**DATE:** 04.18.2018  
**TO:** ProTrak  
**FROM:** Mitesh Baxi  
Traffic Engineering

■ **THE POINTE RETAIL AT BARCLAY [Subdivision Plan Review]**

# Standard Street Lighting Plan Gallery Park Boulevard

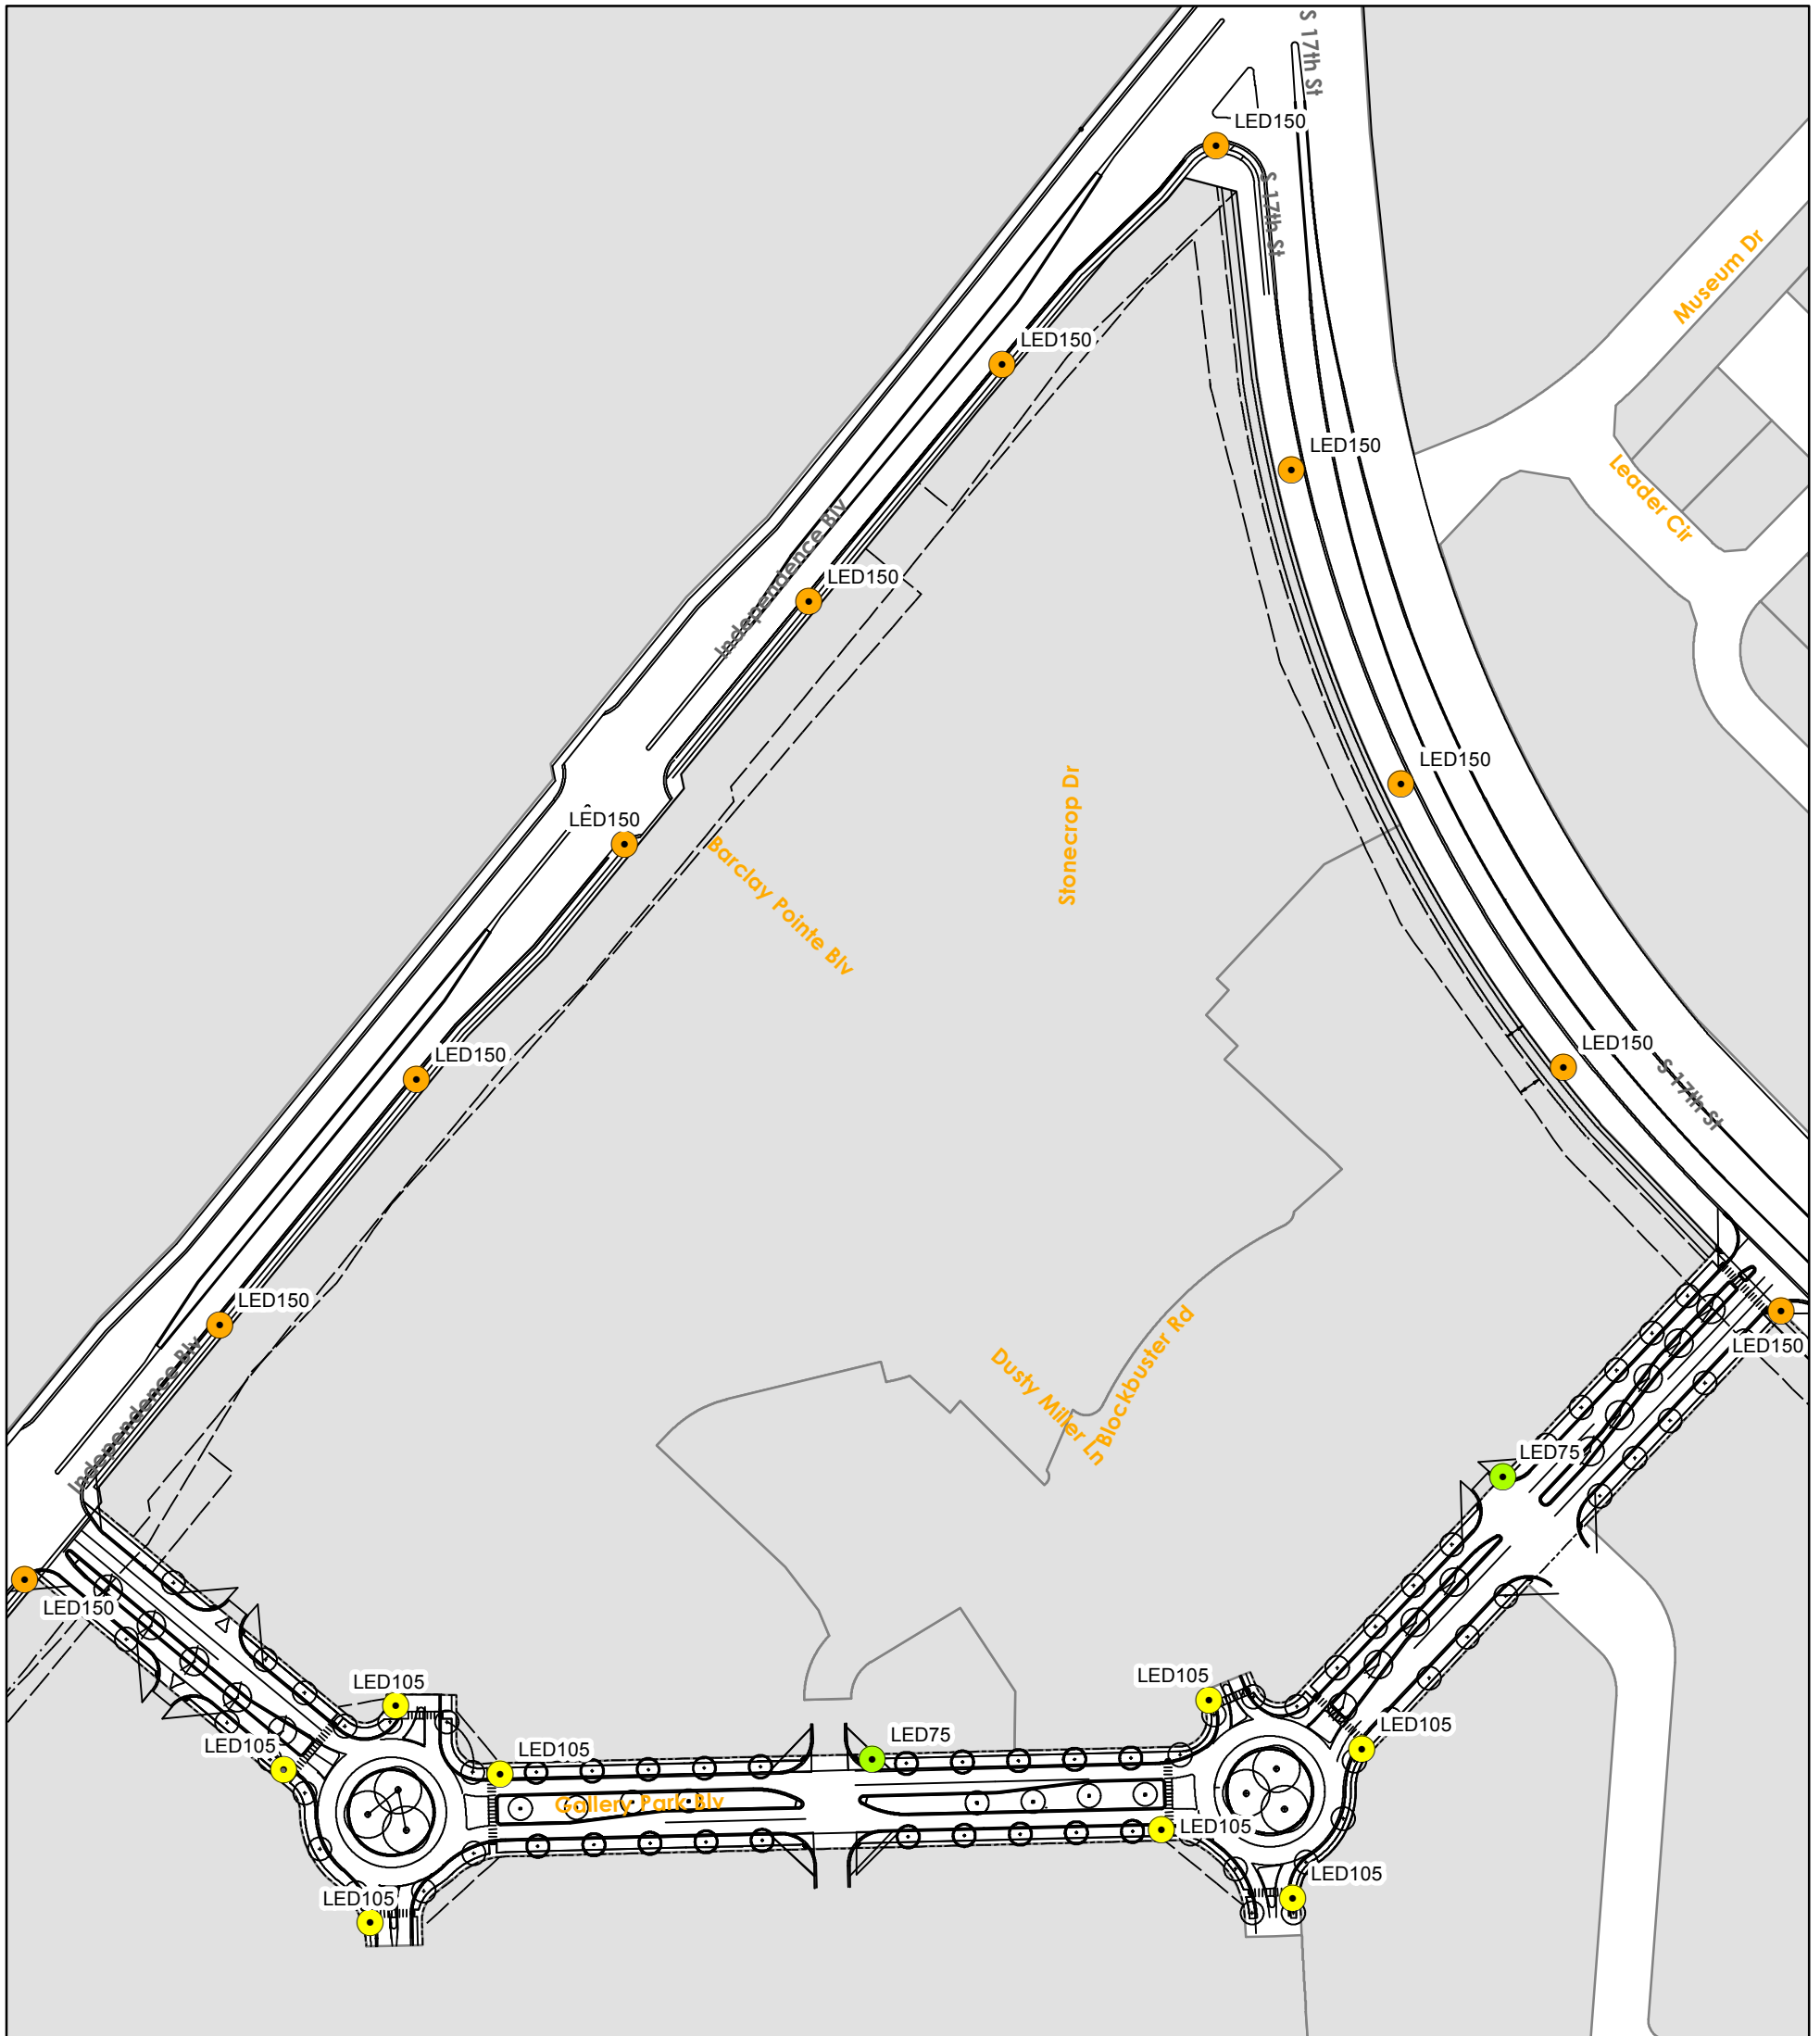
10. A layout for the Standard street lighting has been provided with the review. Minimum of *ten* standard street lights are required for this sub-division in addition to the *eleven* standard street lights on S 17<sup>th</sup> St and Independence Blv. Although, developers may choose to provide any extra lights or ornamental. Any installations above the criteria of Standard street lighting, will be considered as non-standard and has to conform to the City's non-standard street lighting procedure as per the policy.
